# Agenda Item

Application of James Cantrell for a Major Modification of the conditional site plan and other conditions of RSM (Residential Small Lot Mix) zoning approved pursuant to CZ-18-22025, for six single-family homes, at 3446 Midway Road.

PETITION NO: CZ-21-1245234 (2021-3158)

**SUBSTITUTE**

**SITE PLAN**  
SHEET **SK-07**

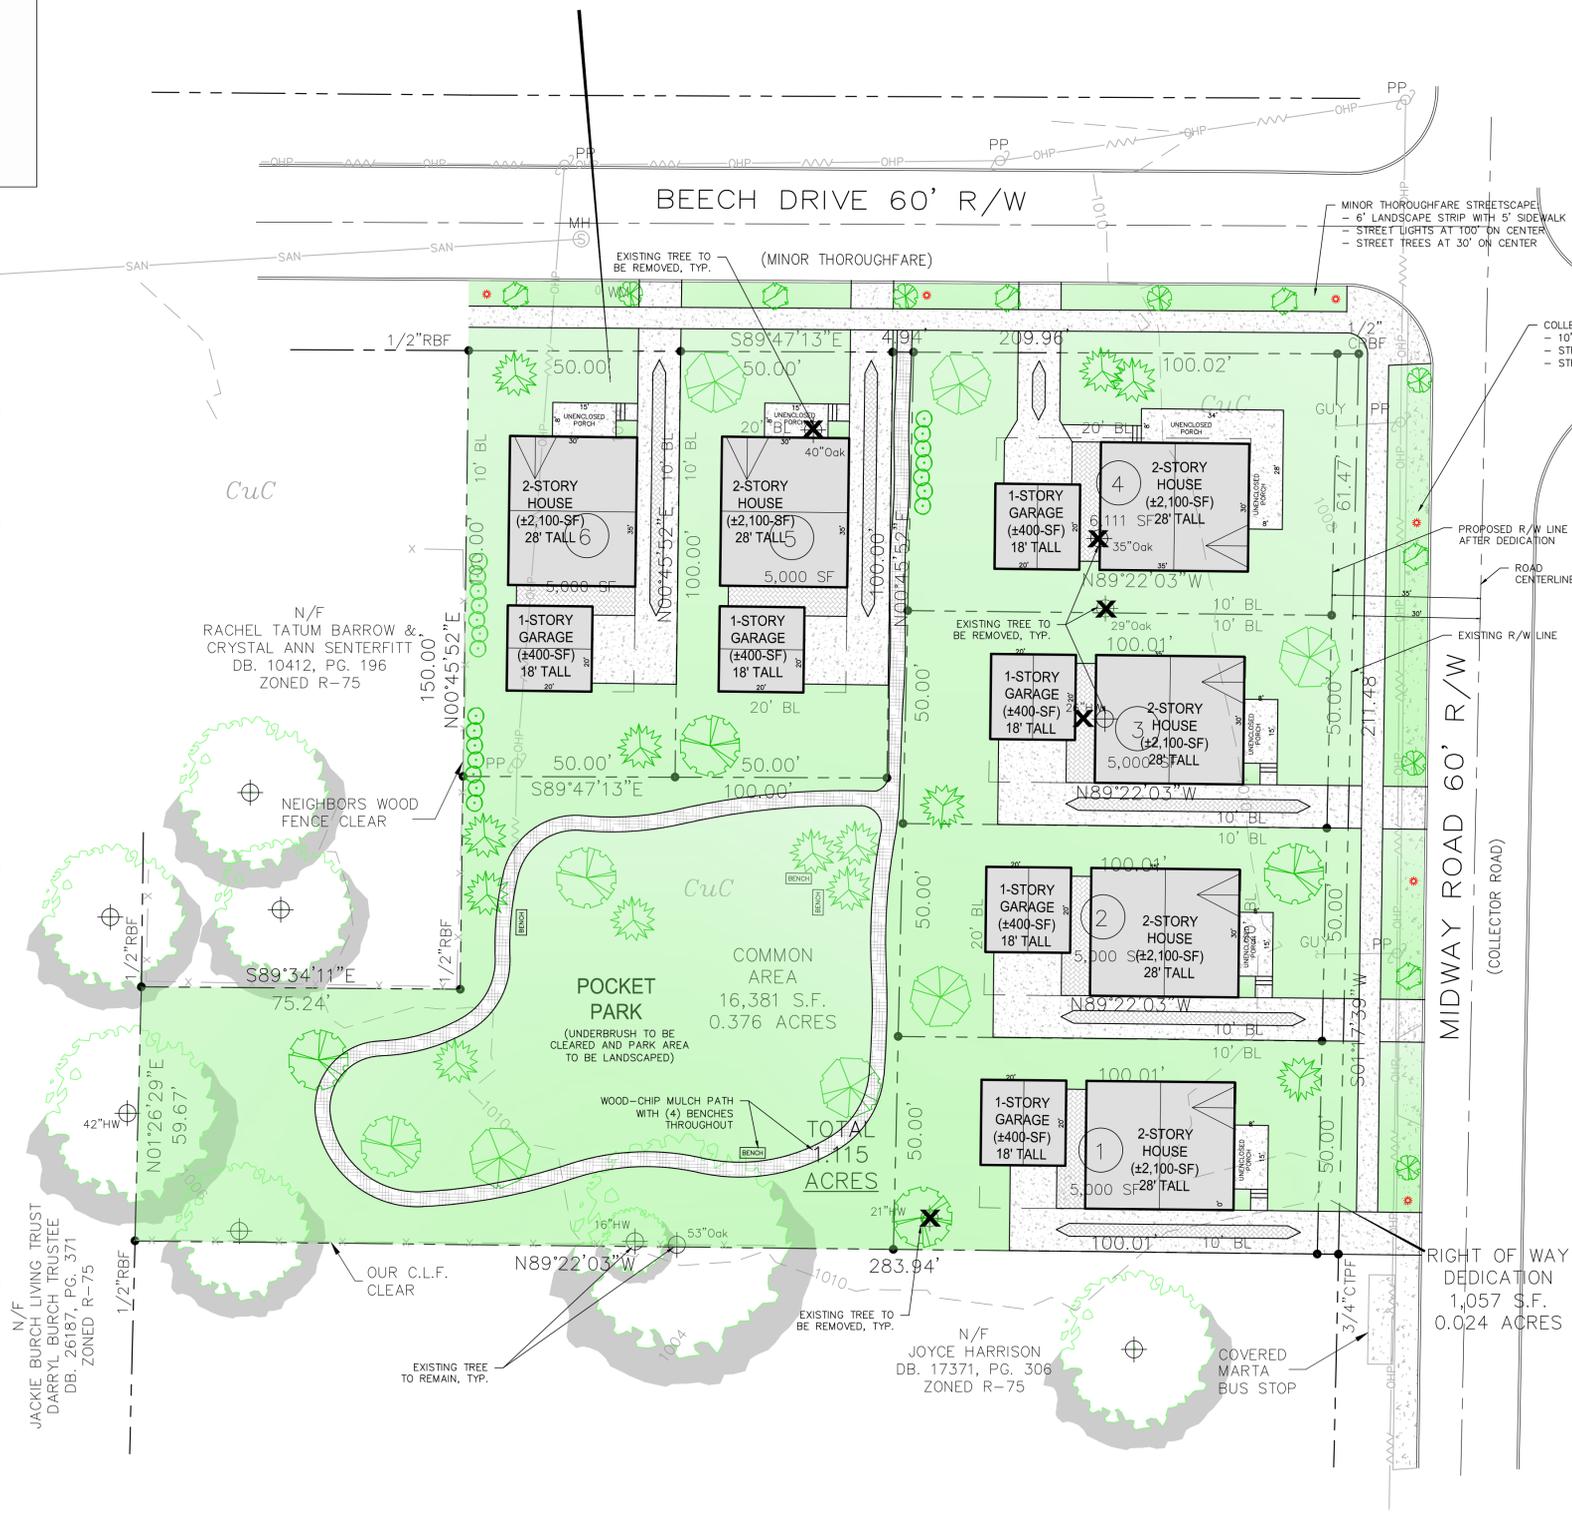
1. *The plan has been revised to move the driveway locations along Midway Road further away from the Midway Road/Beech Drive intersection to provide for safer access and traffic flow along Midway Road (see revised plan dated 11/18/21);*

2. *The plan has been revised to show more enhanced open space features including a pedestrian trail with benches and attractive landscaping;*
3. *The applicant has addressed the impact criteria of Section 7.3.5 of the zoning ordinance relating to compatibility with surrounding uses and transportation impacts (see attached titled “Impact Analysis” by Contineo Group); and*
4. *The applicant has submitted written justification for the reason the modification request needs to be provided on the revised plan (see attached revised plan dated 11/18/21).*

**#1 - ADJUST TO NEW SITE LAYOUT PLAN**

**#4 - REMOVE CONDITION SINCE THERE IS NO INTERNAL ROAD**

**#6 - REMOVE CONDITION SO DEVELOPMENT FEELS LIKE PART OF COMMUNITY INSTEAD OF A SEPARATE GATED CLUSTER OF HOMES**

1. The subject property shall be developed for a maximum of six single-family detached homes in substantial conformity to the site plan titled "Midway Meadows" and dated 11/18/21. The location of driveways shall be subject to approval by the DeKalb County Transportation Department. To the extent that there is any conflict between the site plan and the other approved conditions, set forth below, the written condition shall control.
